# APPLICATION FOR A CERTIFICATE OF APPROPRIATENESS – STAFF REPORT

COA-0033-2019 308 S BOYLAN AVENUE

Nature of Project: Construct rear addition; install wheelchair lift; alter balcony railing; install

# MONTFORT HALL , 308 S BOYLAN AVE TREE PROTECTION PLAN PHASE 1 SCALE : $\frac{1}{32}$ " = 1'-0"

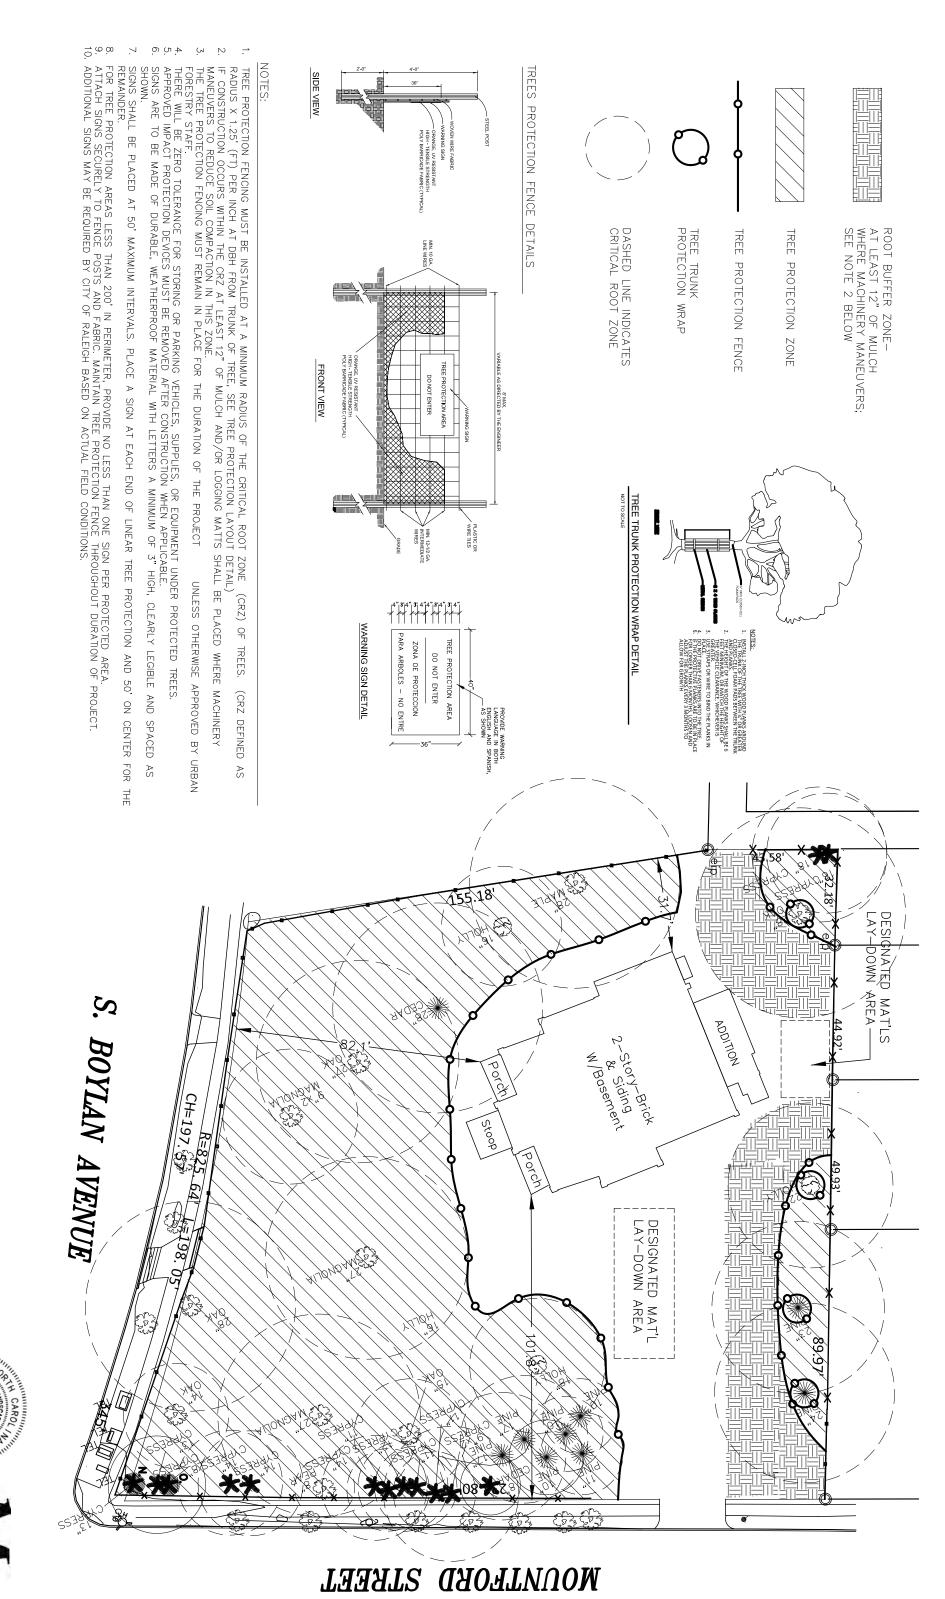
16\* Phase 1 of the tree protection plan was provided.

- 1. That a tree protection plan be implemented and remain in place for the duration of construction.
- 2. That details and specifications for the following be provided to and approved by staff prior to construction or installation:
  - a. Balcony railing details;
  - b. New Juliet balcony detail drawings;
  - c. Walk-out balcony detail drawings;
  - d. Detail photos of trim and casings to be matched;
  - e. Wheelchair lift specifications;
  - f. Painted steel handrail and guardrail specifications;
  - g. Decorative security gate specifications;
  - h. French door specifications and section;
  - i. Rear entry door specifications and section;
  - j. Eave details.

North Elevation, 1967

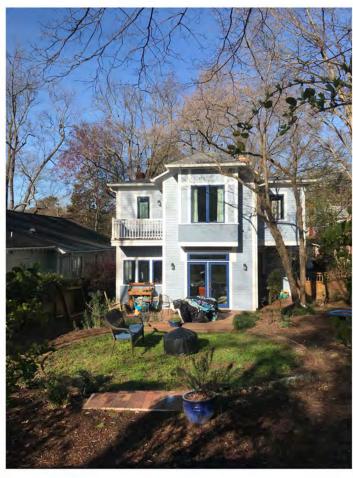
- 12\* A new Juliet balcony is proposed for the north elevation. This balcony is based on documentation of the property from 1967 that indicates a balcony previously existed in the same location. Detailed drawings were not provided.
- 13\* A walk-out balcony with a new French door is proposed for the west façade on the previous addition. Detail drawings were not provided.
- 14\* The application also proposes the restoration of the columns on the north and south porches. The extant columns are non-historic PVC piping with concrete bases. The applicant proposes replacement with 10" wood columns, capitals, and bases.

Enlarged view of proposed guardrail detail

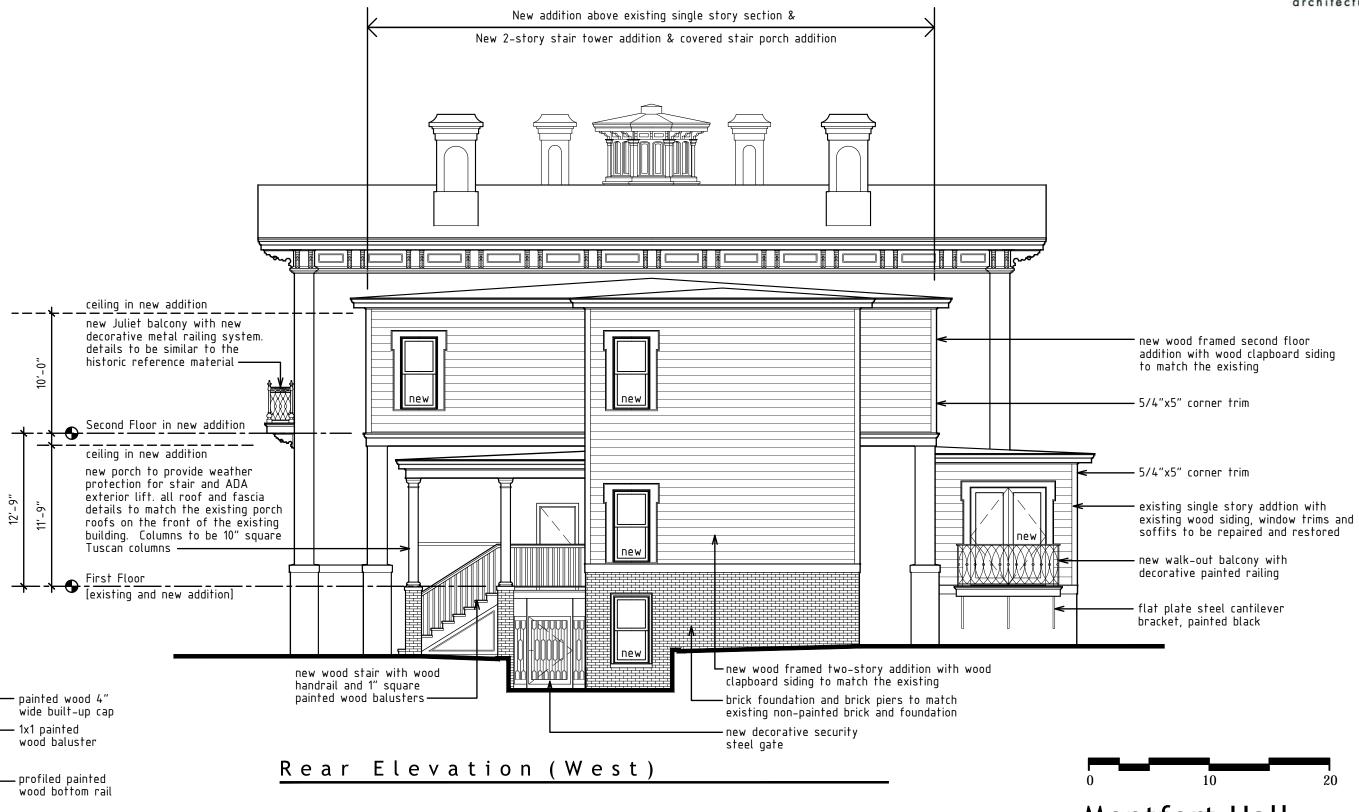
- 10\* The applicant provided photographs of other rear additions to properties in Boylan Heights.
- 11\* The application proposes the repair of the Juliet balcony on the east façade. The existing railing is proposed to be removed and replaced with a decorative railing that is based on the railings present on The Barracks, a property in Tarboro designed by the same architect.
